## Comments and Response Report

### The Proposed Construction of an Access Road, Residential Dwelling on Portion 76 of the Farm 216 Uitzicht, Brenton, Knysna

COMMENTS	RESPONSE
COMMENTS RECEIVED IN RESPONSE TO THE DRAFT BASIC ASSESSMENT REPORT – 3 September 2020 to 3 October 2020	
<b>STATE DEPARTMENTS</b>	
Forestry, Fisheries & The Environment (DFFE) – Melanie Koen – 30 September 2020	
<p>1. Forestry is responsible for the implementation and the enforcement of the National Forest Act (NFA), Act 84 of 1998 as amended and the National Veld and Forest Fire Act, Act 101 of 1998 as amended (NVFFA). Thank you for giving Forestry this opportunity to comment on above application.</p>	
<p>2. Forestry studied the supporting documents for the above-mentioned application and the following points related to Forestry's mandate i.e. the implementation of the NFA is applicable</p> <ol style="list-style-type: none"> <li>a. The above proposal still has to undergo a land-use planning application through the Knysna Municipality: Land-use Planning Section.</li> <li>b. Forestry will thus formally comment on the land-use application firstly before providing further comment to above application.</li> <li

Site Development Plan

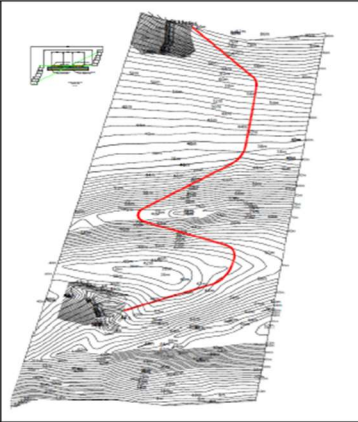
The road is proposed over 2 pristine dunes

Post fire Knysna Sand Fynbos in very good condition

Noted.

**Figure 3** – Architectural plan of the proposed main dwelling

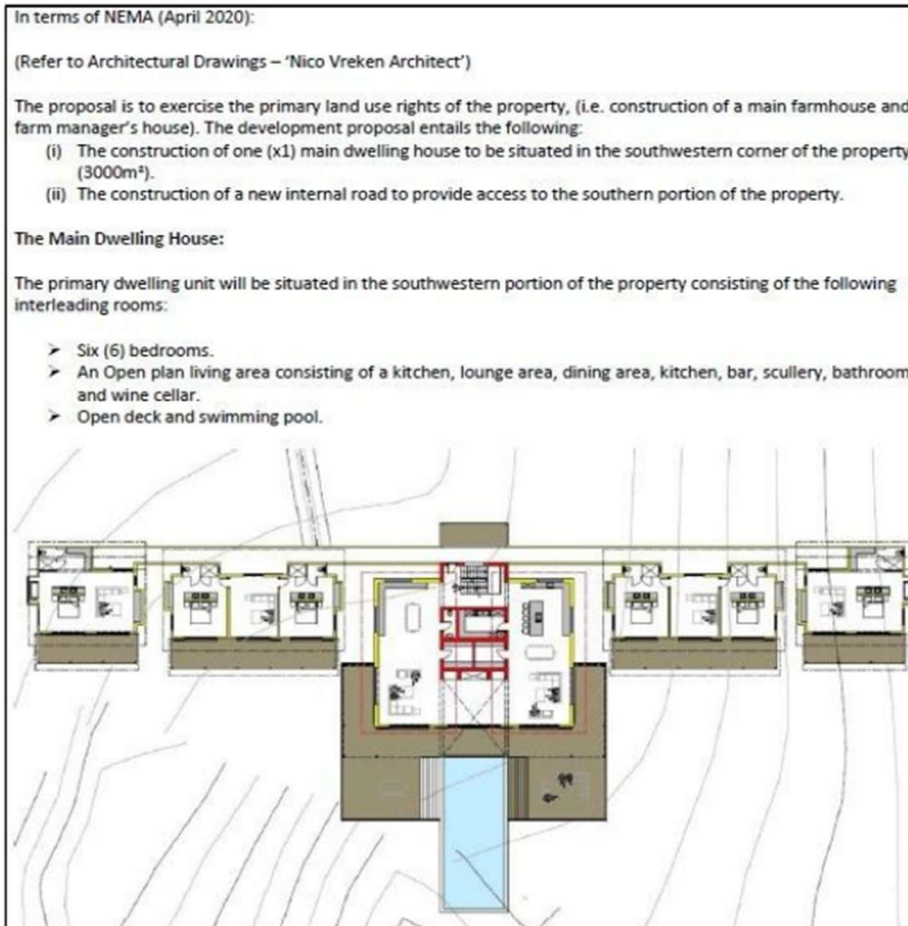
Only a basic floor plan of the preferred main dwelling proposed for the south-western corner of the site has been submitted for consideration (see Fig. 3 below), despite a reference to other architectural drawings. However,

there are no details pertaining to elevations, sections, 3D views, floor levels, or any external views from different angles. Reference is made to the approximately 3,000 m<sup>2</sup> disturbance area, without clarifying how much of this is building footprint, disturbance during construction, parking areas, water storage, utility areas sewerage disposal facilities, topsoil storage areas and so on. The floor plan in Fig. 3 has no scale and we can only guess that the main dwelling appears to be approximately 55m long and could be double or even triple storey.

The applicant acknowledges the comment regarding limited architectural detail in the DBAR. A basic conceptual floor plan for the main dwelling—

located in the south-western corner—has been provided at this stage, as the project is still in the environmental assessment phase. Full architectural details, including elevations, sections, and 3D views, will be submitted with the formal land use application to the Knysna Municipality, in line with statutory requirements and public participation.

**Figure 5 – The vegetation of Uitzicht 76**

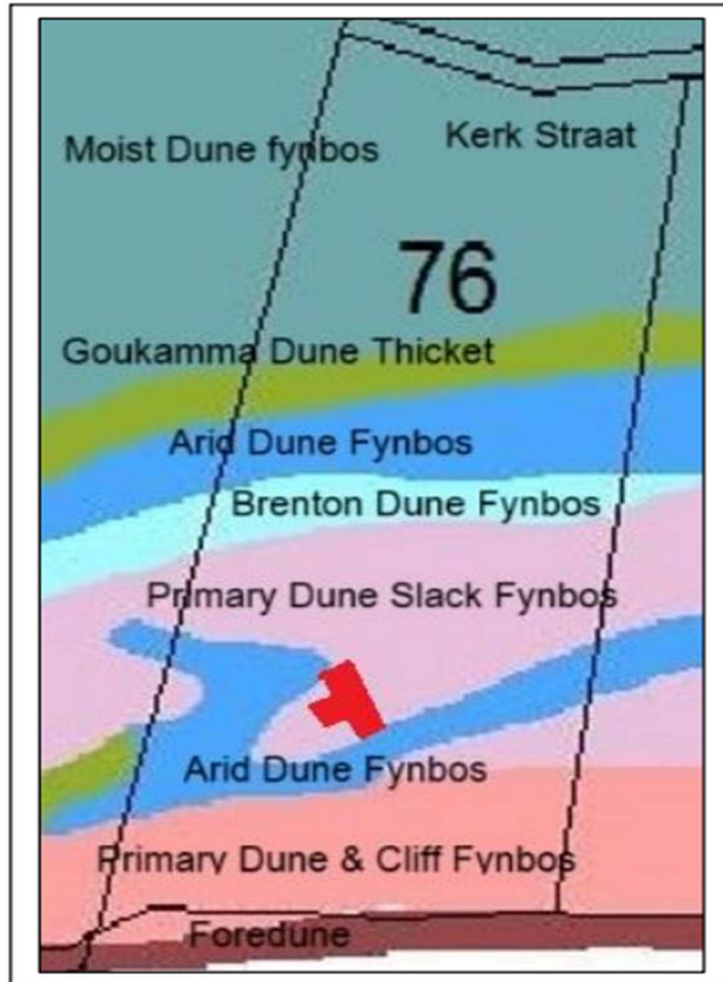
The Plant Species and Terrestrial Biodiversity Assessment (Fouché 2024) looked at the SANBI vegetation types (VEGMAP, 2018) but also at Vlok's vegetation types (2005) which are on a finer scale (see Fig. 5). Knysna Sand Fynbos (FFd10) is equivalent to Vlok's "Moist Dune Fynbos", which is south facing and moderately steep in places. Goukamma Dune Thicket (AT36), which Mucina & Rutherford had named South Cape Dune Fynbos (FFd11) in 2006, is only present as a thin strip in Vlok's vegetation mapping, found at the bottom of the primary dune. Higher up the dune this becomes Arid Dune Fynbos, which is north facing, very steep and sandy near the summit, and erodes easily if the vegetation is removed. The proposed "internal road" has to overcome this substantial obstacle. After the top of the dune it descends into south facing and gently sloping Brenton Dune Fynbos (BDF), a very rare vegetation sub-type poorly represented in the Goukamma Nature Reserve (GNR). In the shallow valley Primary Dune Slack Fynbos occurs, which is only found on the Brenton dunes and even scarcer than BDF. On this incredibly rare vegetation the applicant wants to build a 3000 m<sup>2</sup> dwelling, which will be high enough to be seen from Buffalo Bay behind the highest primary

Fouché (2024) found that the vegetation now mapped as Goukamma Dune Thicket contains a number of Red List plants and has a HIGH sensitivity ecologically. From an environmental perspective it would be difficult to find a place less suited to building a house.

Figure 5 – The three alternatives assessed in the DBAR – Alternative 4, the least environmentally damaging, was not considered

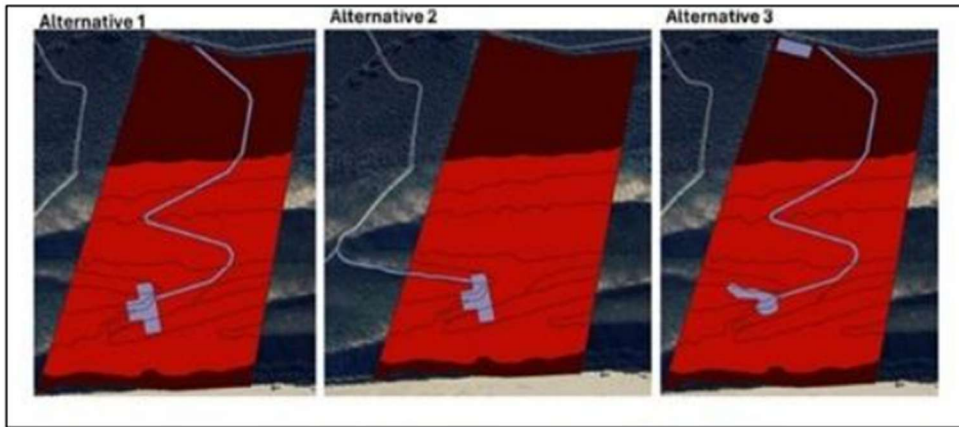
The DBAR Illogically selects the worst two Alternatives (1 & 3 ref BAR page 76) contrary to the conclusion that Alternative 4 is the best as per Page 77 and ignores the fact that an internal road is not allowed under the WCLUPGRA 2019 guidelines pertaining to Core 1 SPC. The applicant needs to be interrogated as to why Alternative 4 (Fig. 6) is not being considered, and Alternative 1 is the preferred option.

The proposed development on Portion 76/216 will affect sensitive fynbos and strandveld vegetation within a Critical Biodiversity Area 1 (CBA 1). The impact assessment recommends Alternative 4 as the best layout, with Alternative 2 also being viable. Both result in Minor or Negligible impacts, while Alternatives 1 and 3 risk requiring offsets due to Moderate impacts. Alternative 4 is preferable because it minimizes project footprint, reduces fire risk, limits landscape fragmentation, and results in less than 1% transformation of the property, compared to over 2% for other options.
